Agenda Item # 7

SUB-002557-2023 & MOD-002587-2023

Christ United Methodist Church Subdivision,
Resubdivision of Lot 1, Resubdivision of Lot 2A

- Subdivision approval to create two (2) legal lots of record
- Modification of a previously approved Planned Unit Development

SITE PLAN

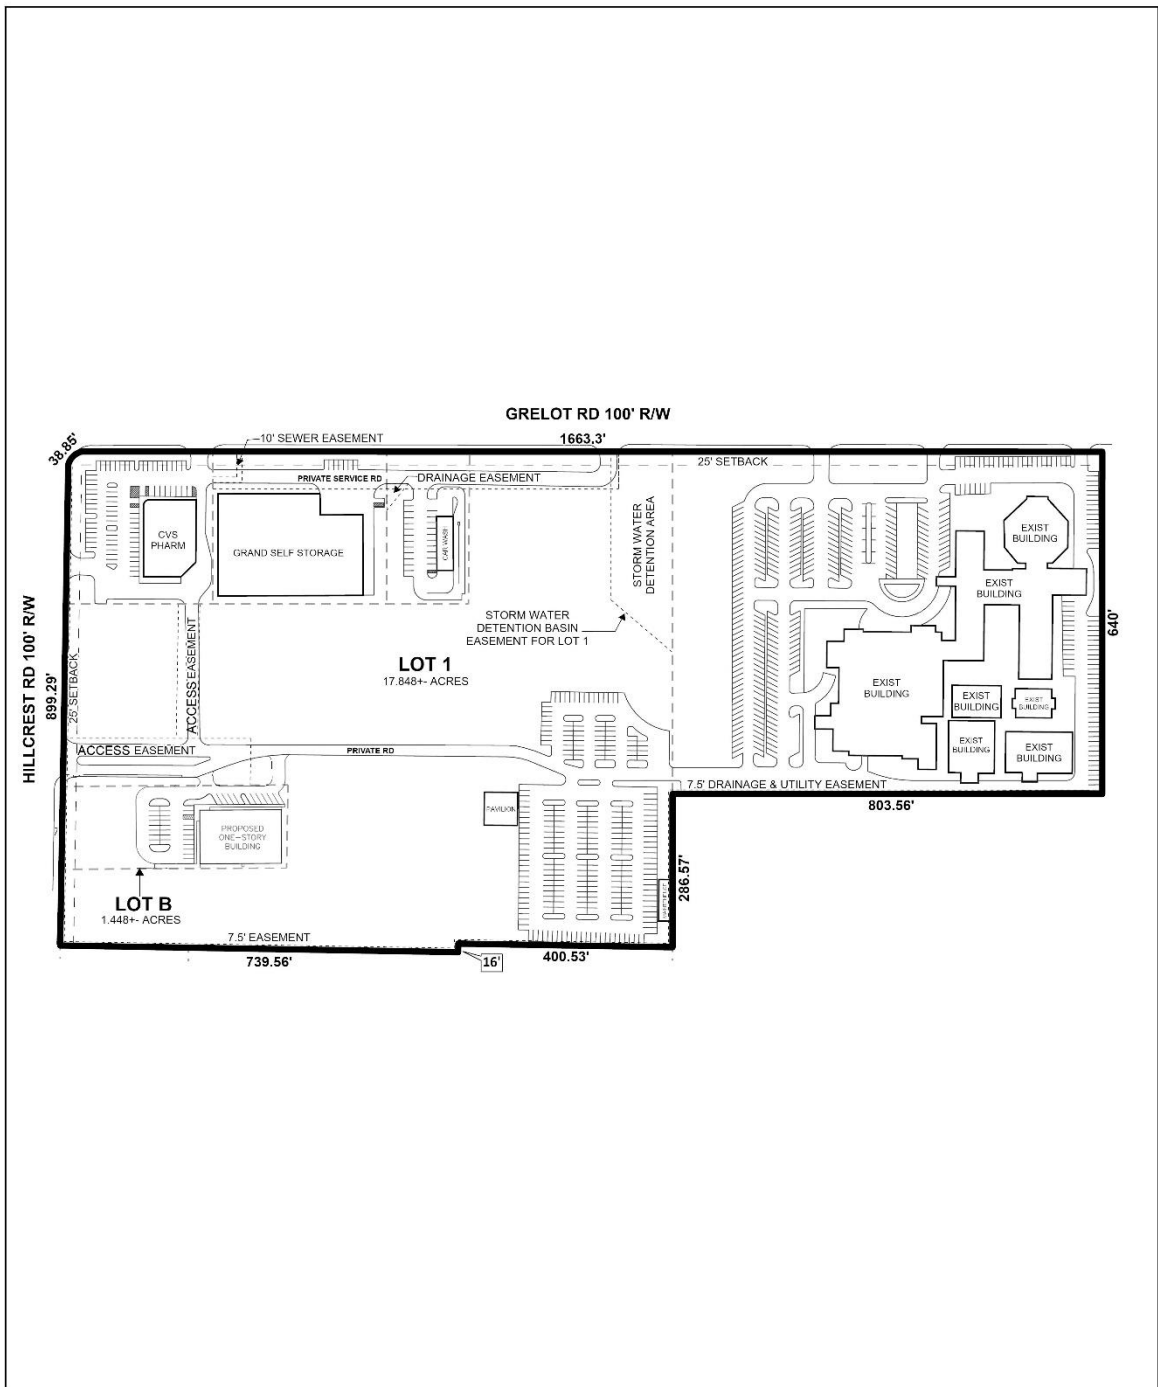
The preliminary plat depicts several existing easements: three (3) access easements, a stormwater detention basin easement, and a drainage and utility easement on the proposed Lot A. These easements should be retained on the Final Plat, if approved, with a note stating that no structures are allowed to be erected in any easement, without the easement holder's permission.

There is a note on the preliminary plat stating that new construction will comply with the minimum setback requirements of the historic district overlay requirements. As the subject site is not located in a historic district, this comment should be removed from the plat, if approved.

The newly created Lot B is proposing two (2) access points to the proposed Lot A. One of the proposed access points is within an existing access easement, but the other is beyond the easement. If approved, the easement should be extended to include both proposed access points on both the Subdivision plat as well as the PUD site plan.

The site plan submitted has a note stating that any dumpster to be installed at the site will comply with “Section 64-4.D.P. of the Zoning Ordinance”, as well as a note stating that Lot B will use on-site trash pickup. If approved, the site plan should be revised to remove the note about dumpsters.

Notes on the site plan relating to tree planting and landscape area requirements, in addition to parking screening, have references to the former Zoning Ordinance, not the new Unified Development Code (UDC). If approved, all code references should be updated to reflect the applicable standards of the UDC.

3. Extension of the access easement along Hillcrest Road to include both proposed access points from Lot B;
4. Removal of the note stating "Any dumpster to be installed in compliance with Section 64-4.D.P. of the Zoning Ordinance";

5. Revision of notes on the site plan referencing tree planting and landscape area requirements, in addition to parking screening, to reflect the applicable standards in the UDC;
